## CMB Meeting Minutes #144

SUBJECT: Configuration Management Board Meeting # 144 – Rev. No. 0

Contract No.	<u>1200 Tunnels</u>	Date	<u>10/11/2013</u>
PCC No.	<u>1252-14</u>		
PCC Title	<u>Modifications to AWSS Facilities at 4<sup>th</sup> and Bryant Streets</u>		
PCC Initiator	<u>Michael B. Smith/SFDPW/IDC/EME</u>	Dept.	<u>Design</u>

CONTRACT NO.	1252
FILE NO.	91,655
DRAWING NO.	AW-501.13
SHEET NO.	0

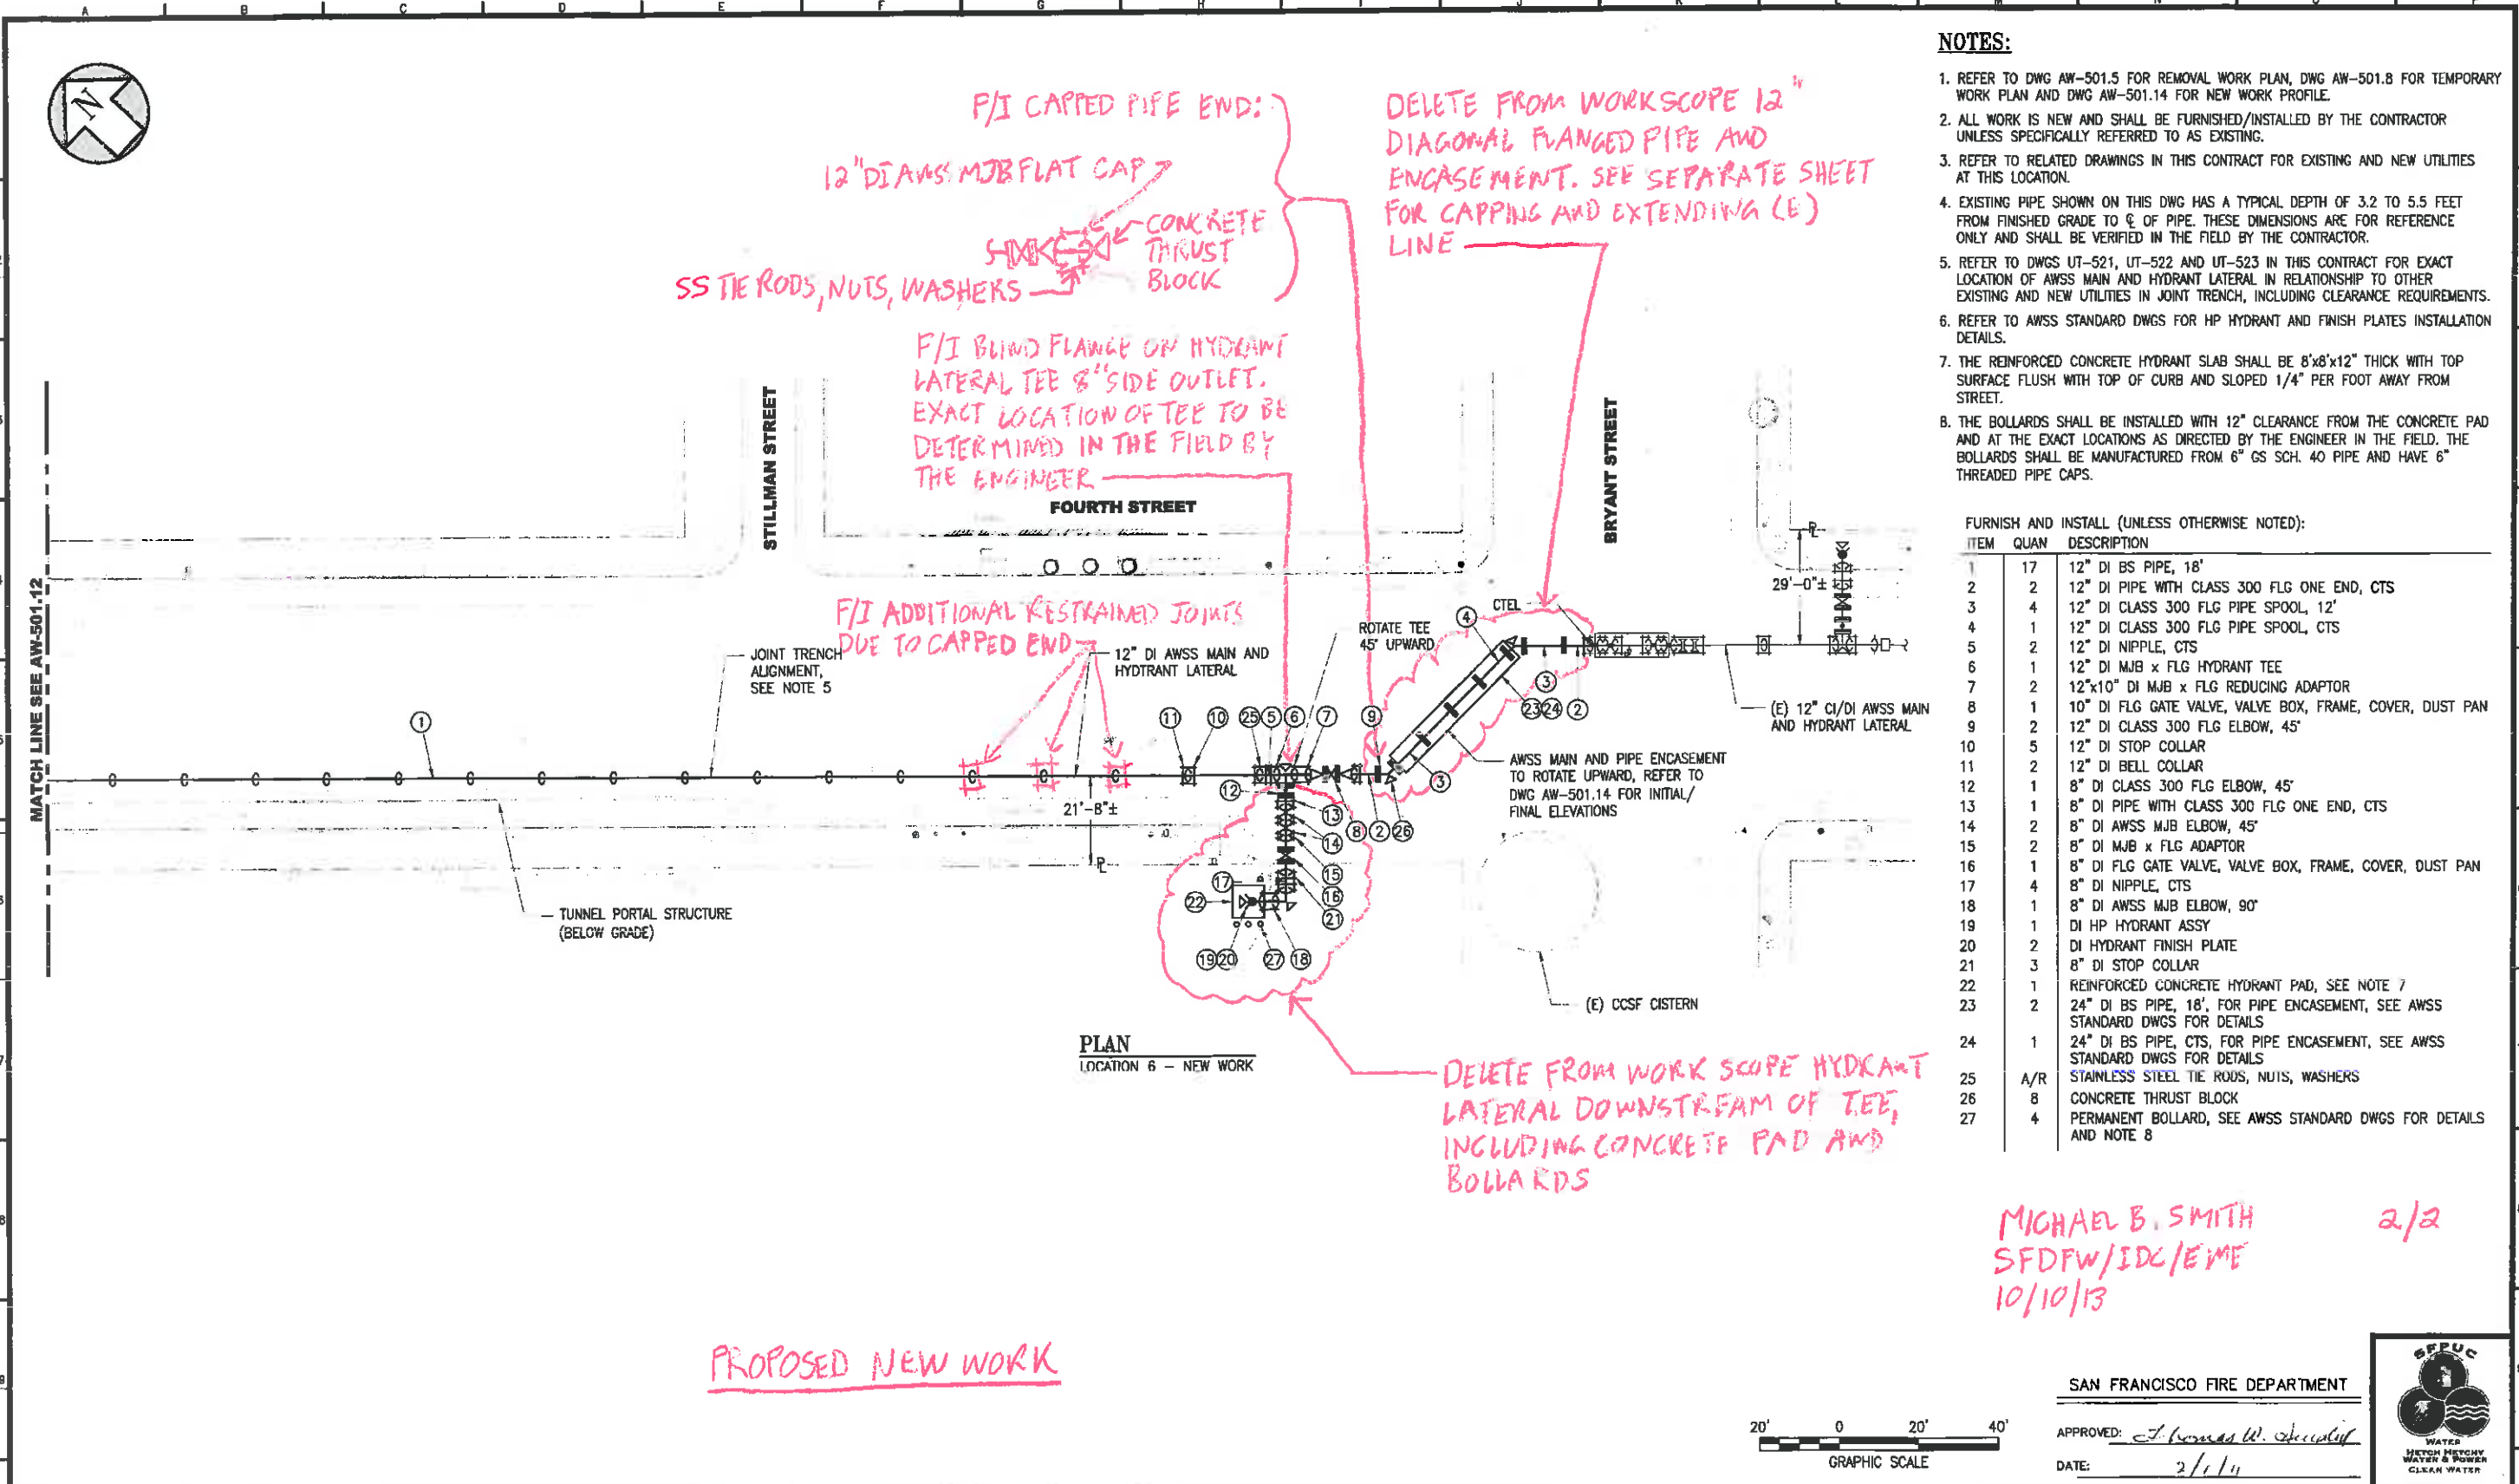
**DELETE FROM WORKSCOPE 12" DIAGONAL FLANGED PIPE AND ENCASEMENT. SEE SEPARATE SHEET FOR CAPPING AND EXTENDING (E) LINE**

**DELETE FROM WORK SCOPE HYDRANT LATERAL DOWNSTREAM OF TEE, INCLUDING CONCRETE PAD AND BOLLARDS**

**Recommended Action:** Delete the proposed 12" diagonal flanged AWSS main and encasement pipe crossing the 4<sup>th</sup> and Bryant Streets intersection as shown on the attached edited drawing AW-501.13. Delete the proposed 8" hydrant lateral to be installed on the I-80 off-ramp as shown on the attached edited drawing AW-501.13. F/I proposed 12" pipe extension and flat cap to the existing 12" CI line to meet AWSS tieback requirements and as shown on the attached edited drawing AW-501.5. F/I hydrant tee per the engineer's direction and cap side outlet as shown on the attached edited drawing AW-501.5.
